DART+ WEST, ORAL HEARING SUBMISSION

SEPTEMBER 2023

ASHTOWN ROAD UPGRADE & ENTRANCE TO ASHTON HOUSE
FOR CASTLETHORN CONSTRUCTION

OS Map of existing Ashtown Road (shown in grey), with Iarnrod Eireann proposal overlaid (shown in red).

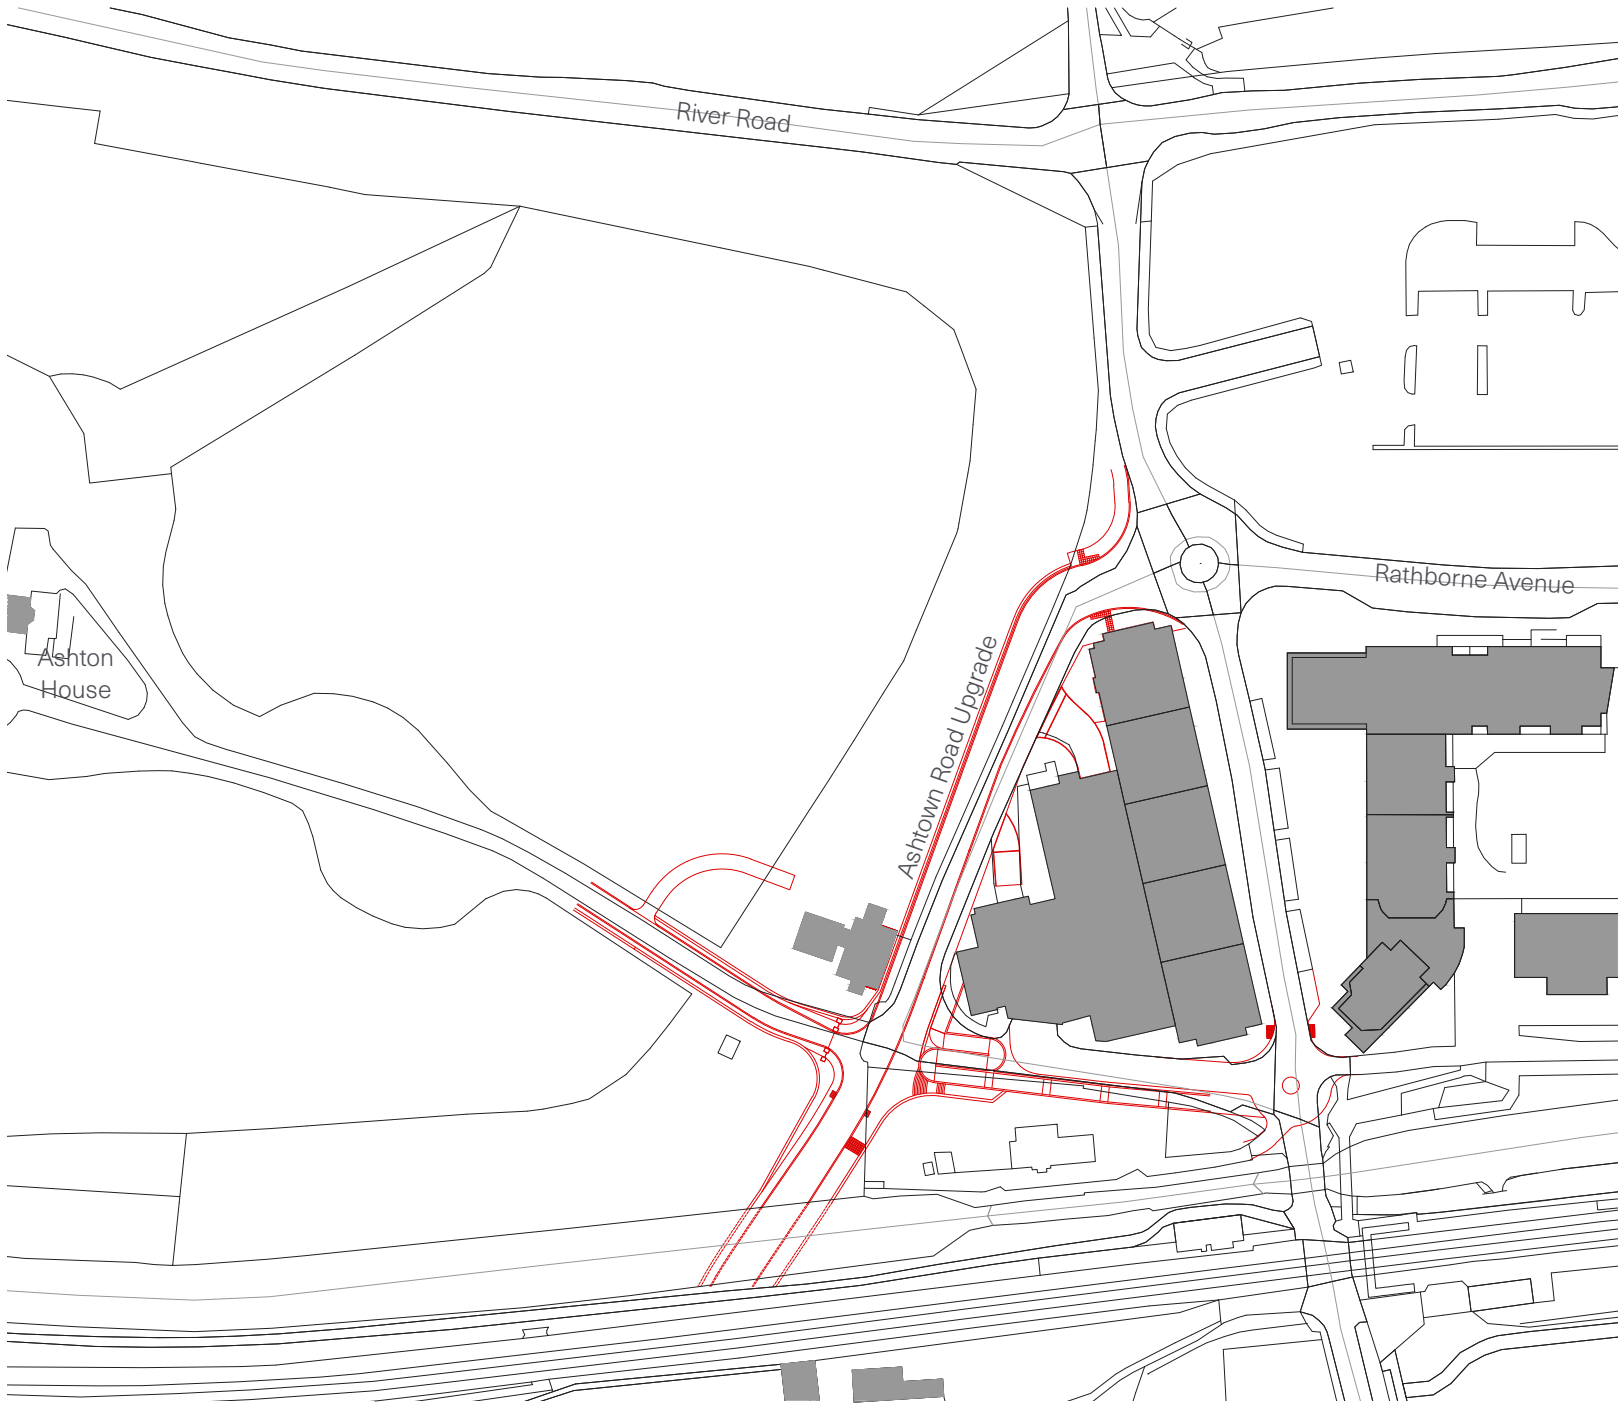
The level of the proposed road, at the point where it passes the entrance to Ashton House, with its stone piers & gates and gatelodge (Protected Structures), is c. 37.62m OD, which is c. 2.74 metres below the existing road level at that position.

The proposed Ashtown Road upgrade also widens and realigns the existing road. The new alignment overlaps with the existing position of the stone piers & gates (Protected Structures), and therefore necessitates their removal, and reconstruction elsewhere, in a position to be agreed. The details of the proposed arrangement are described in more detail on the following page.

While Castlethorn are supportive of the upgrade of Ashtown Road in principle, we are concerned that the local access arrangements to Ashton House will result in an significant deterioration in the quality and nature of the access to Ashton House, in particular in relation to the following:

- Road Safety: The existing access area is c. 30 metres from the underpass under the canal and railway, and in the proposed Iarnrod Eireann design, the Ashtown Road Upgrade is still rising steeply at the point that it passes the entrance to Ashton House, resulting in traffic from Ashton House exiting onto a steeply sloped, fast moving carriageway;
- Protected Structures: The entrance to Ashton House is defined by stone piers and gates, and a gatelodge, all of which are Protected Structures. The setting of the Protected Structures and the relationship between the piers & gates and the Gatelodge is severely impacted by the proposals.

Drawing showing Iarnrod Eireann proposal (shown in grey), overlaid on existing conditions (shown in red).

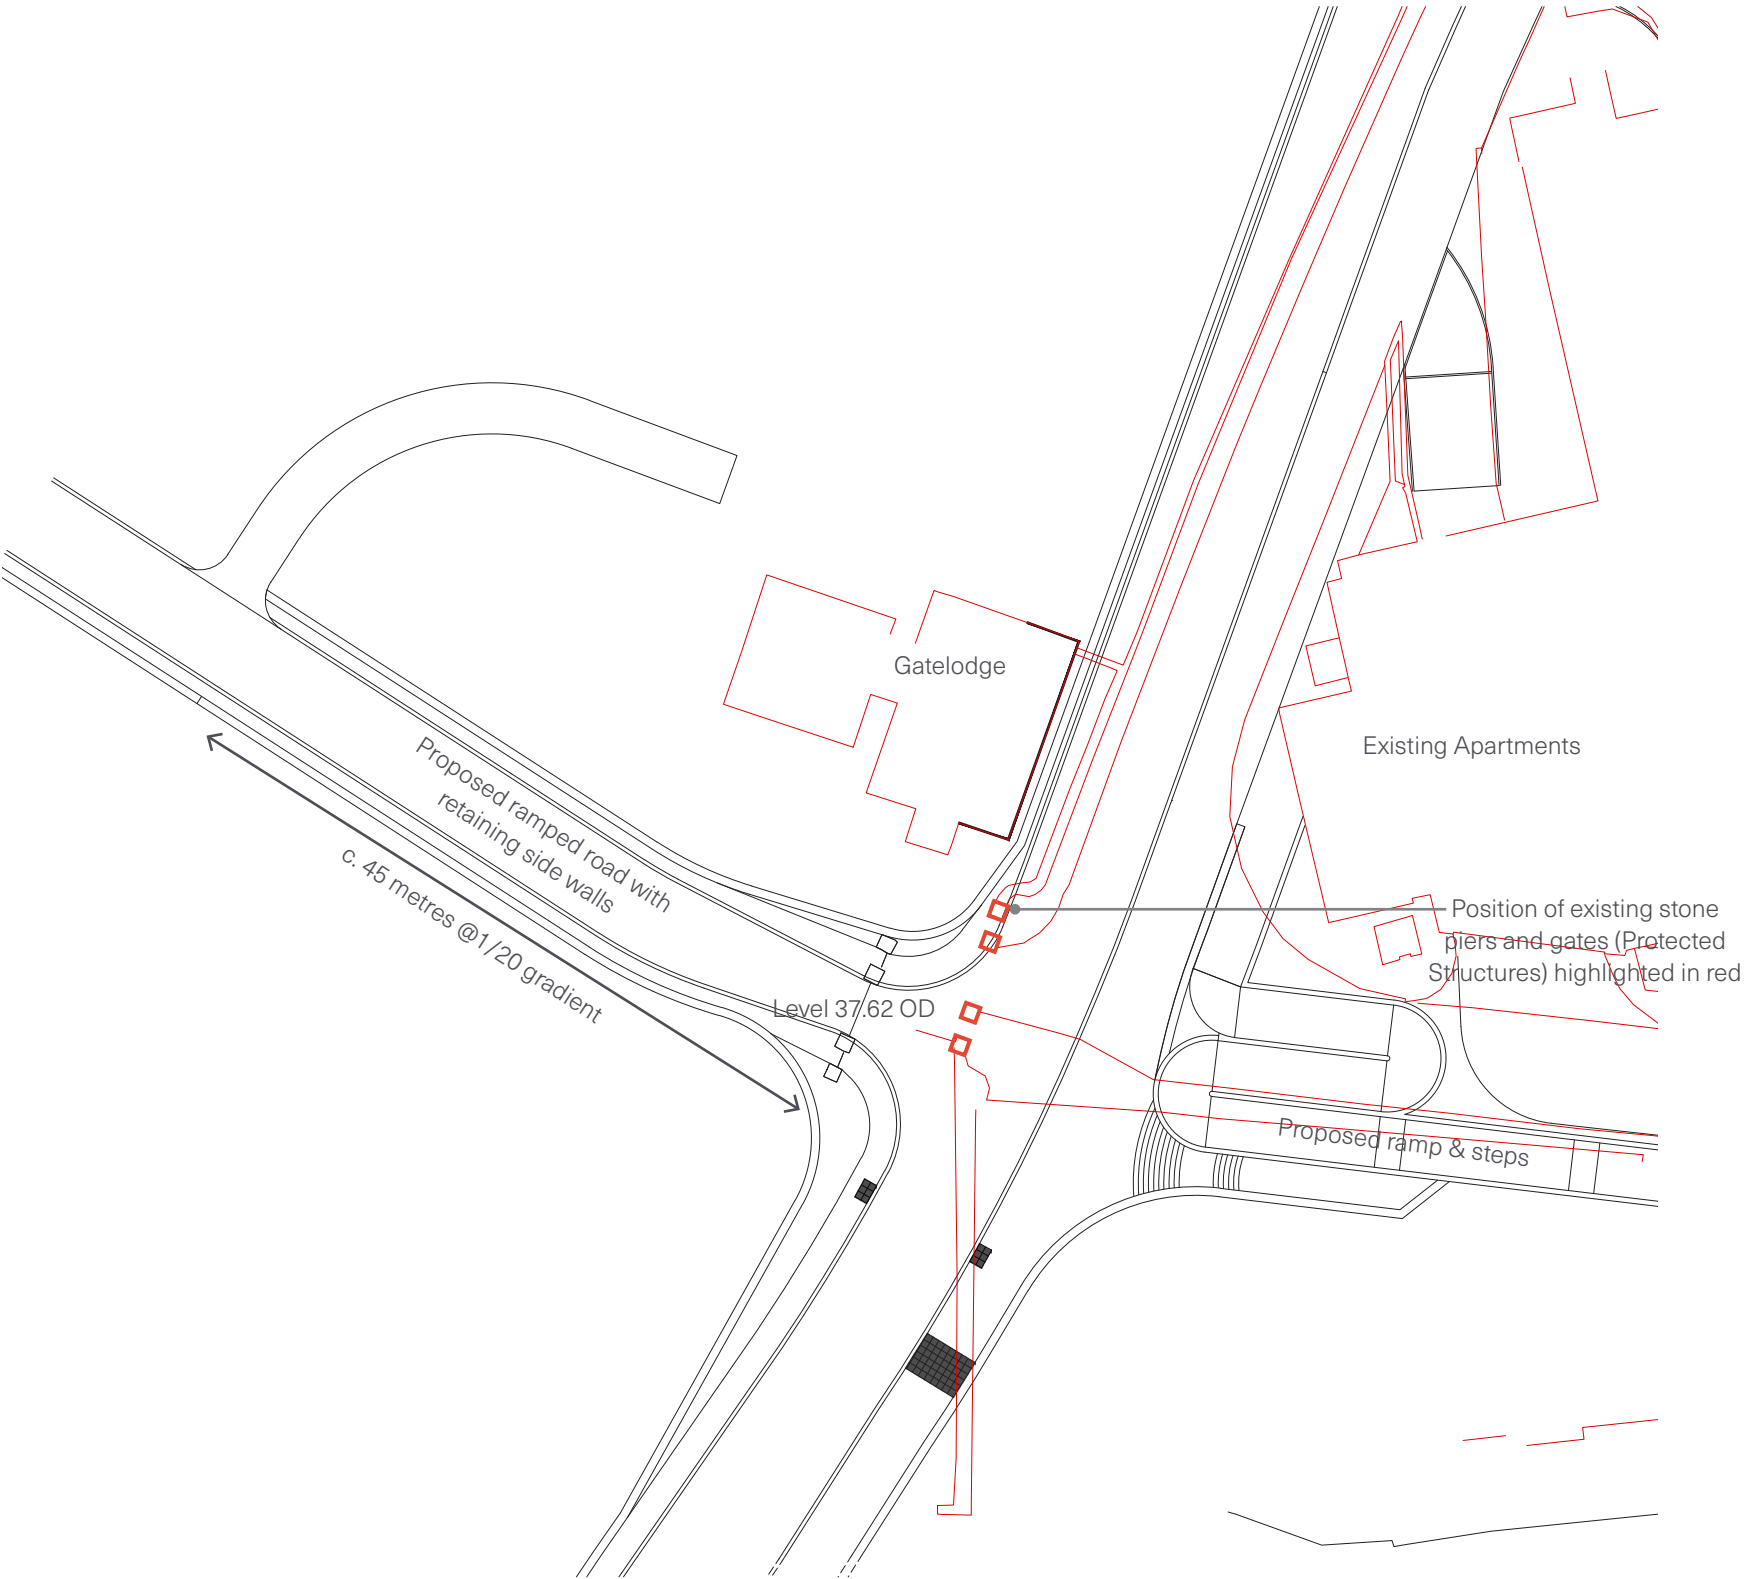
Iarnrod Eireann have proposed that the existing position of the stone piers & gates (Protected Structures) be removed and reconstructed in a position slightly south-west of their existing location, and that they would be placed at the level of the proposed Ashtown Road upgrade, i.e. c. 2.74 metres below their existing level.

Iarnrod Eireann have proposed that the newly positioned piers would continue to serve as the point for vehicular and pedestrian access to Ashton House, and propose that a ramped road, which would be c. 40-45 metres in length, located inside the grounds of Ashton House, would navigate the proposed level change of c. 2.7 metres between the Ashtown Road upgrade and existing ground levels. Retaining walls will be required on the sides of the ramped road to deal with the level difference between the road and the adjacent ground levels.

We are concerned that the proposed entrance condition will create an unsafe, unpleasant, “tunnel” or “underpass” effect for entrants into Ashton House, and will sever the relationship between the existing stone piers & gates and the gatelodge, all of which are Protected Structures.

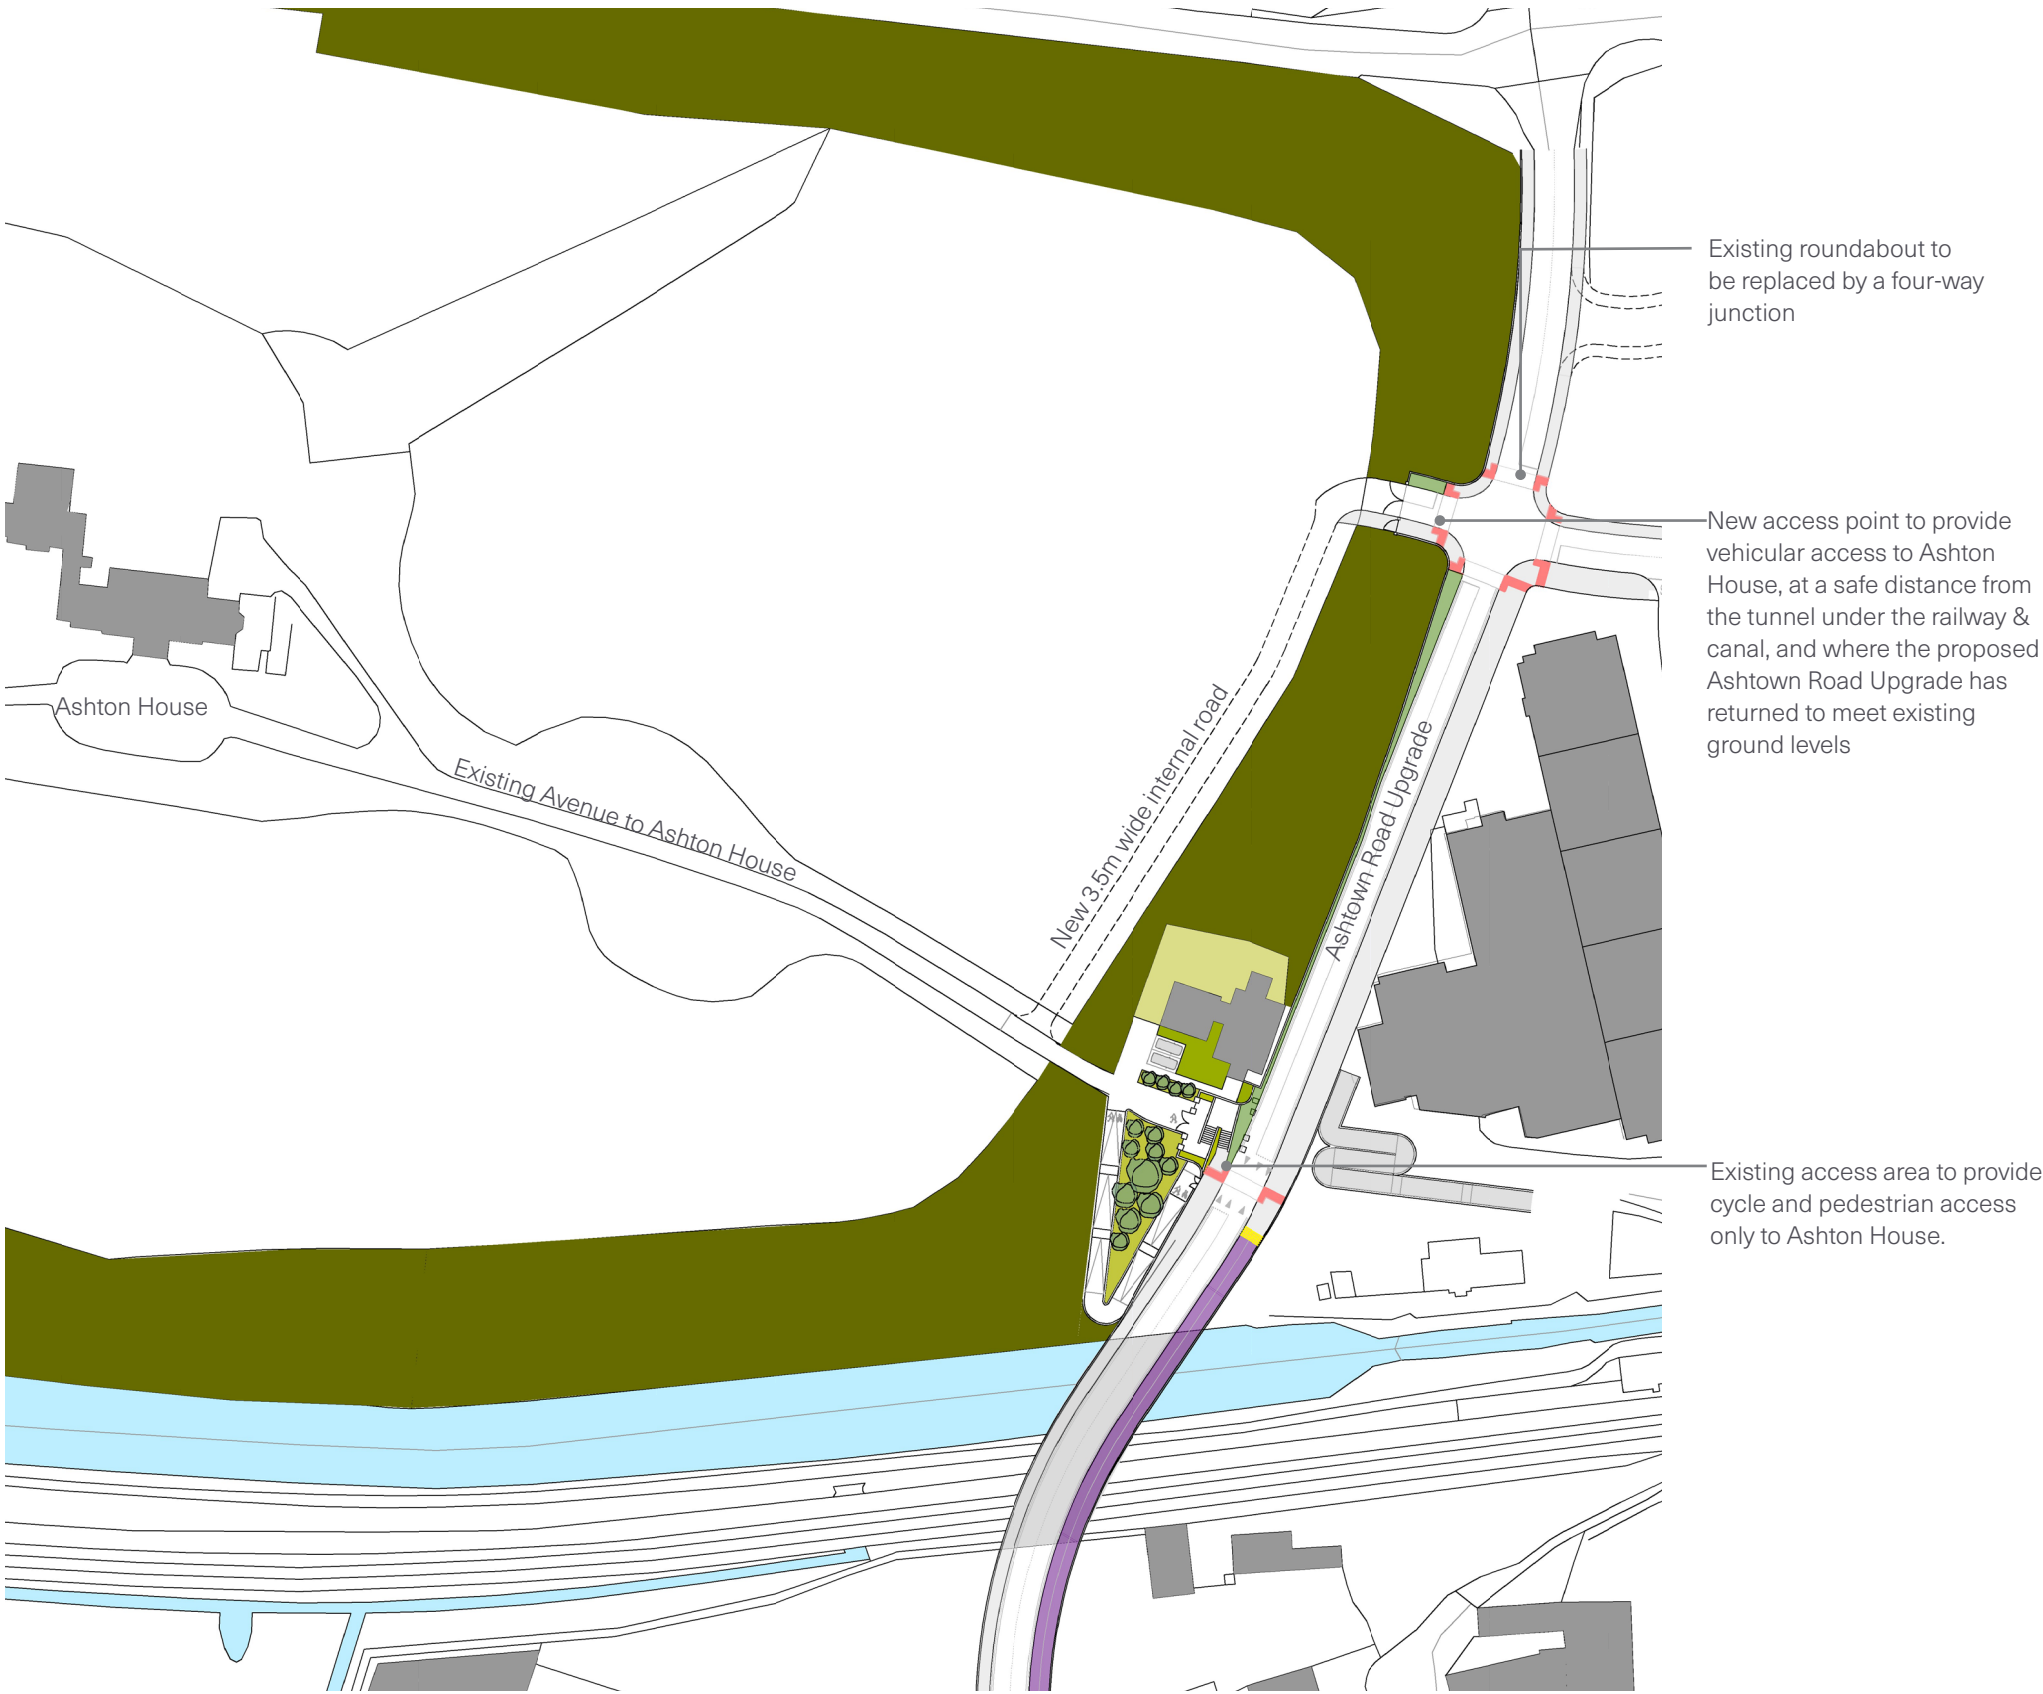
Proposed Ashtown Road Upgrade & Ashton House entrance by Iarnrod Eireann, with change in ground level of c.2.7metres at the existing entrance to Ashton House. As can be seen in the 3d model, the stone piers and gates are dwarfed by the scale of the retaining walls required by the Ashtown Road Upgrade, and the relationship between the stone piers & gates and the Gatelodge is severed.

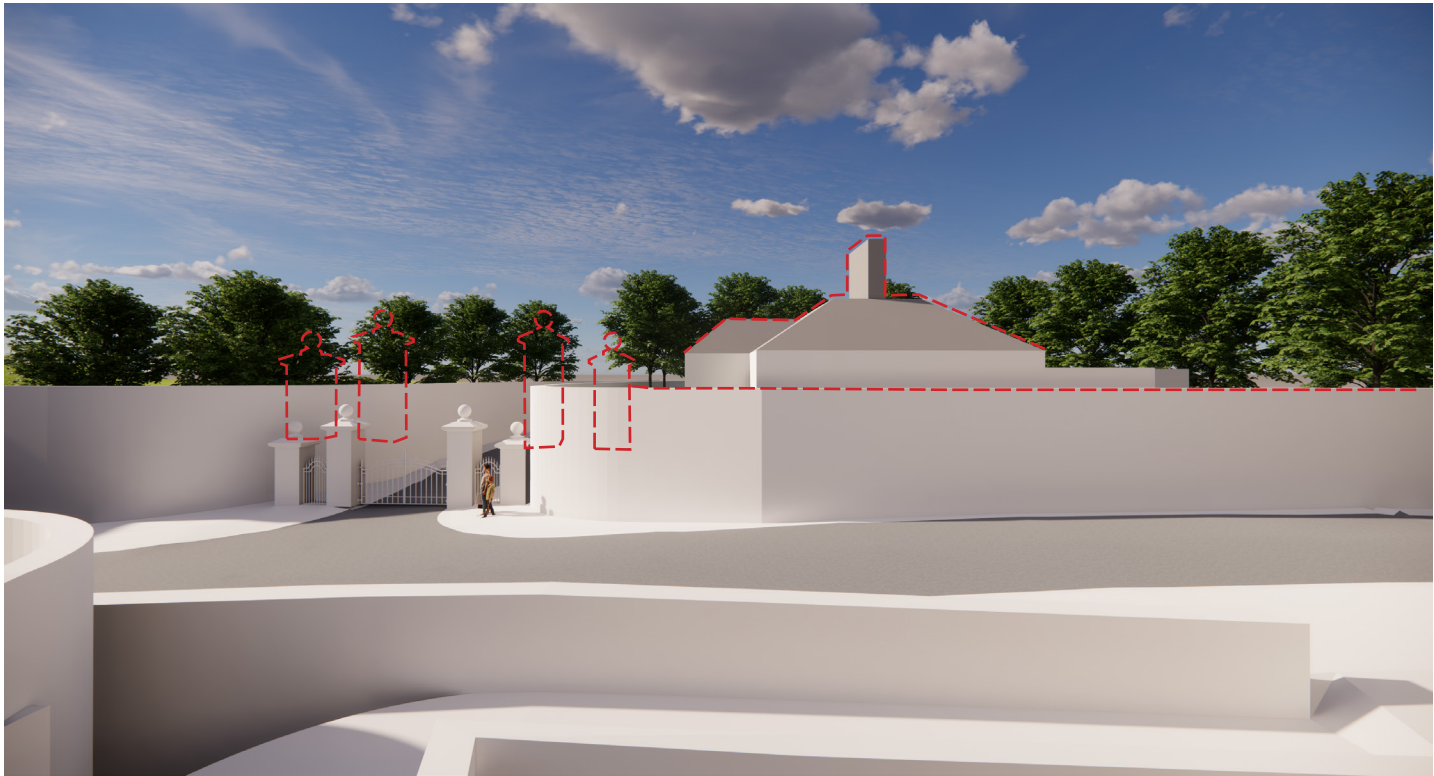
3d view of Ashton House entrance from Ashtown Road (Iarnrod Eireann Proposal)
The stone piers & gates (Protected Structures) are removed from their existing position and rebuilt as shown, at a level c. 2.7metres below their existing position. A new boundary wall, which forms the western edge of the Ashtown Road Upgrade, with estimated heights of between 4.0 - 5.0 metres, acts as a retaining wall to the Ashton House Lands.
Vehicular and pedestrian access to Ashton House is via the repositioned gates, and the new, steeply sloped access road that would be required within the Ashton House Lands is visible through the gates. Retaining structures will be required on both sides of the new access road to Ashton House, which will create a “tunnel” effect, and overshadowing on the access road.

We accept that the position and level of the Ashtown Road Upgrade will inevitably change the environment in the vicinity of the existing entrance to Ashton House, with the wider carriageway, increased traffic volumes and 2.7m level change all having a significant impact. However, in the Iarnrod Eireann proposal on the left, the stone piers are dwarfed by the new retaining walls, and the ramped access to Ashton House will be dark and tunnel-like. In the Castlethorn proposal on the right, the stone piers maintain a relationship with the gatelodge, and the proposed steps and planting mitigate the visual impact of the inevitable level changes that arise from the Ashtown Road Upgrade.

3d view of Ashton House entrance from Ashtown Road (Castlethorn Proposal)
The stone piers & gates (Protected Structures) are removed from their existing position and rebuilt as shown - their position aligns with the western wall of the gatelodge, and their ground level is the same at their existing ground level.
The new position of the stone piers and gates creates a “bell mouth” area, where steps and planting are located, which facilitates pedestrian movement between Ashton House and the Ashtown Road Upgrade.
A new boundary wall, which forms the western edge of the Ashtown Road Upgrade, with estimated heights of between 4.0 - 5.0 metres, acts as a retaining wall to the Ashton House Lands - the position of the proposed steps and planting creates a landscape transition in scale that mitigates the visual impact of their height.
